SERVICE BULLETIN SB00.19

Machines/Models:LX31/41/50 4WD **Serial Numbers:** 1000 -1409

PURPOSE: Enhance Brake Durability

PROCEDURE REQUIRED: Install Orifice Fitting, adjust the Counterbalance and Bi-Directional Relief Valves

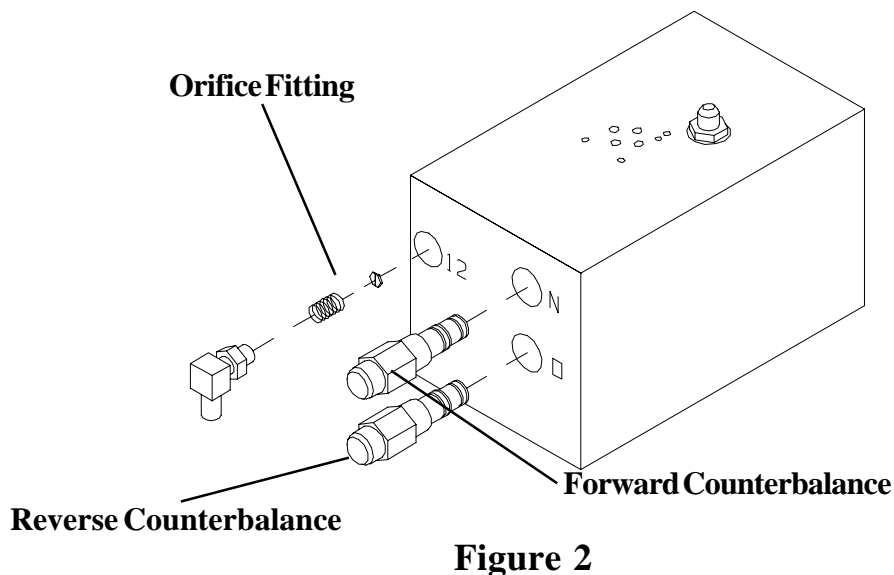
1. Locate the Left (Right) Bi-Directional Relief Valve (see Figure 1).
2. Loosen the Bi-Directional Relief Valve locknut (remove tamper proof cap if applicable).
3. Turn the valve clockwise until it gently rests against the seat.
4. Turn the valve counterclockwise 4 1/4 turns.
5. Torque the locknut to 3 Ft. Lbs (4 Nm).
6. Repeat steps 1 through 5 for the Right Rear Bidirectional Relief.

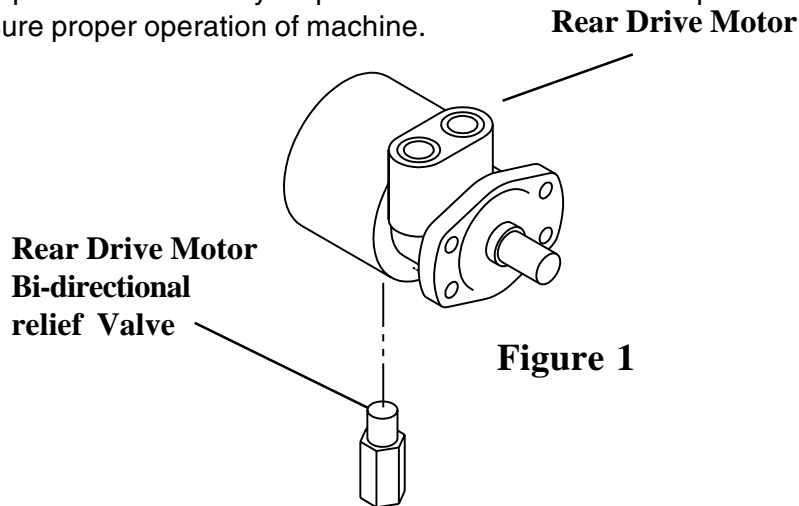
1. Locate the Forward (Reverse) Counter Balance Valve (see Figure 2).
2. Loosen the locknut.
3. Turn the valve clockwise until it gently rests against the seat.
4. Turn the valve counter clockwise 4 1/4 turns.
5. Torque the locknut to 3 Ft. Lbs (4 Nm).
6. Repeat steps 1 through 5 for the Reverse Counter Balance Valves as follows.

1. Locate port 12 on the Main Hydraulic Manifold (see Figure 2).
2. Remove the Line at the fitting at Port 12.

3. Remove the fitting in Port 12 on the Main Hydraulic Manifold.

4. Insert the supplied spring and orifice (with the slot side out)(see Figure 2).

5. Reinstall the fitting and torque to 10 to 20 Ft. Lbs (13-26 Nm).

6. Reinstall the line and torque to 18 to 20 Ft. Lbs (22-26 Nm).
